RESOLUTION NO. 1904

A RESOLUTION OF THE CITY OF WILSONVILLE ADOPTING AN ALIGNMENT AND CROSS-SECTION FOR BOECKMAN ROAD FROM 95TH AVENUE TO GRAHAMS FERRY ROAD; AND IDENTIFYING CERTAIN DESIGN DETERMINATIONS AS AN IMPLEMENTING REFINEMENT TO THE 2003 TRANSPORTATION SYSTEM PLAN.

**ENGINEERING DEPARTMENT**
STAFF REPORT & RECOMMENDATION

SUBJECT: Boeckman Road Extension Alignment

Boeckman Road - Tooze Road Connector Project
Build Alternatives - Typical Sections
Figure 2-4

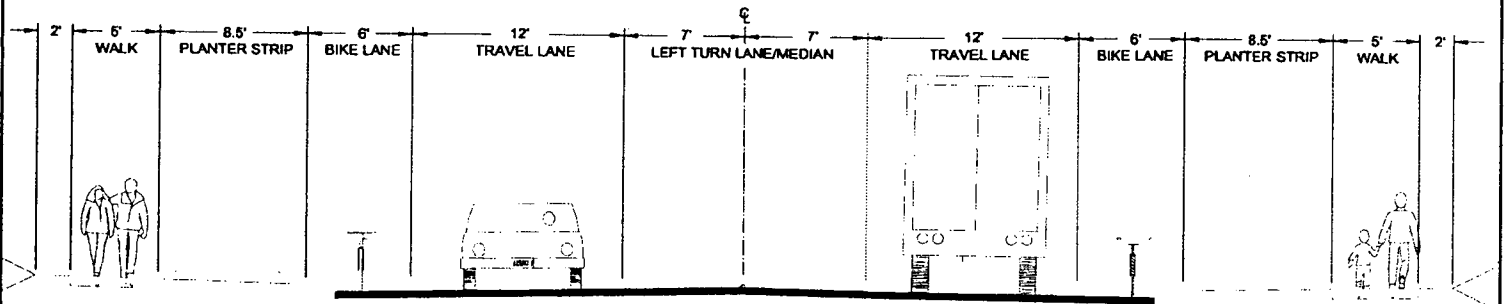
Figure 2-4 – Typical Sections

- The bridge span is being constructed to minimize impacts to the floodway. 14-foot travel lanes seem excessive for the roadway/bridge typical section - wide travel lanes encourage speeding and add to the overall bridge construction costs.

Recommendation: 12-foot travel lanes are recommended to match the roadway typical section. Reduced travel lane width could help reduce the width of the bridge that needs to be constructed, which in turn reduces impervious area and impacts to adjacent natural resources. The project cost savings may also allow for a longer span to be constructed. The final bridge design should provide for passage of wildlife and be constructed as long as the project budget allows, as noted in the Metro parks staff comments.

Response: The 14-foot travel lanes were integrated into the conceptual typical section for the bridge span to increase motorists' comfort levels when trucks are traveling on this section of the roadway (i.e., that the bridge section would not have the center median/turn lane to separate traffic, and thus a slightly wider travel lane would provide more room for motorists and bicyclists on the bridge).

The bridge span length has been designed to avoid raising the 100-year floodplain elevation and is the longest span possible within the project budget. The City of Wilsonville and ODOT have coordinated with Metro Parks and Greenspaces staff and Oregon Department of Fish and Wildlife regarding wildlife passage issues. The proposed bridge height and span width are adequate to allow passage of large mammals, such as deer. Regarding runoff from impervious surfaces, efforts have been made in project planning to minimize the footprint of the roadway facility as much as practicable. Runoff quality and quantity will be treated in accordance with the City of Wilsonville's Public Works Standards. Water quality treatment will be designed to achieve at least 70 percent removal of total suspended solids, which will also remove associated pollutants such as nutrients and metals.

The City of Wilsonville will continue to coordinate with Metro through the final design process. Your comment will be considered in further design of the project.
